**Point Beach Nuclear Plant**

License Amendment Request 257  
Technical Specifications 5.5.8 and 5.6.8,  
Steam Generator Program & Steam Generator Tube Inspection Report  
Interim Alternate Repair Criteria (IARC) for Steam Generator Tube Repair

**WESTINGHOUSE ELECTRIC COMPANY LLC  
RESPONSE TO NRC REQUEST FOR ADDITIONAL INFORMATION RELATING  
TO LTR-CDME-08-11, REVISION 1 NP-ATTACHMENT**

Figure 11-3: Tube Crack Geometry

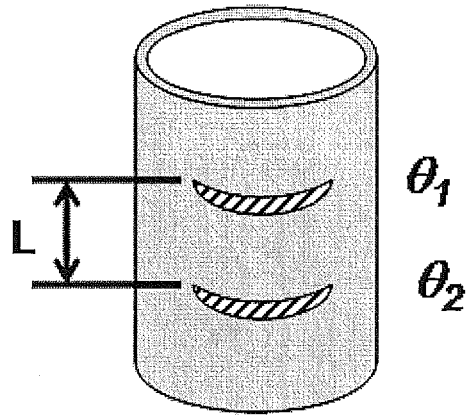
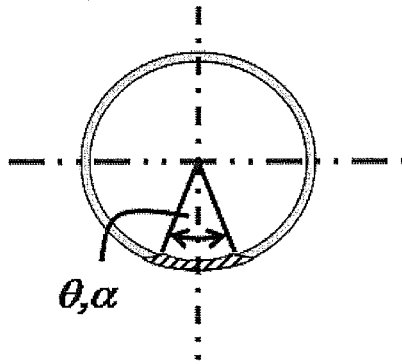
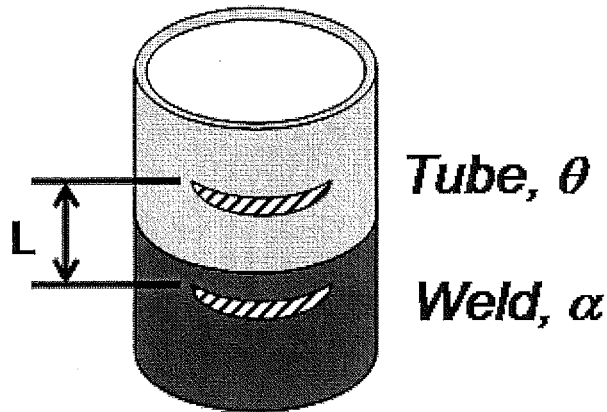
- b. One hypothetical crack plane, which appears more limiting than the one assumed by the licensee, is the cylindrical "plane" defined by the expanded tube outer diameter where the weld is in a state of shear. Assuming a flow stress of 63.7 ksi and an effective weld depth of 0.035 inches (as shown in LTR-CDME-05-209-P, Figure 2-1), the NRC staff estimates that the required circumferential ligament to resist an end cap load of 1657 lb is greater than 180 degrees (without allowances).

The impact of the crack separation analysis is summarized below. Refer to Figures 11-3 through 11-5 for explanations of the crack geometries and combinations of crack-like indications considered in the analysis. Table 11-1 is a summary of the text description of the crack separation analysis impacts. The details described in Table 11-1 apply only to the portion of the tube within the tubesheet 17 inches below the top of the tubesheet (TTS-17 inches).

6	Yes	$\theta_1 + \theta_2 + \theta_n + \alpha > 94$	Possible Crack in Weld	$< 1.00^j$	Sum of total non-overlapping crack angle plus overlap angle greater than $94^\circ$ . Cracks in weld and tube do interact. Plug Tube.

1. See Figures 11-3, 11-4 and 11-5 for tube crack angle and weld crack angle definition.
2.  $\theta_n$  is the sum of any remaining crack angles after the first two crack-like indications. For example, the statement:  $\theta_1 + \theta_2 + \theta_n \leq 203^\circ$  is equivalent to writing:  $\theta_1 + \theta_2 + \theta_3 + \dots \leq 203^\circ$ .
3. Separation distance, L, is measured from the tube end.
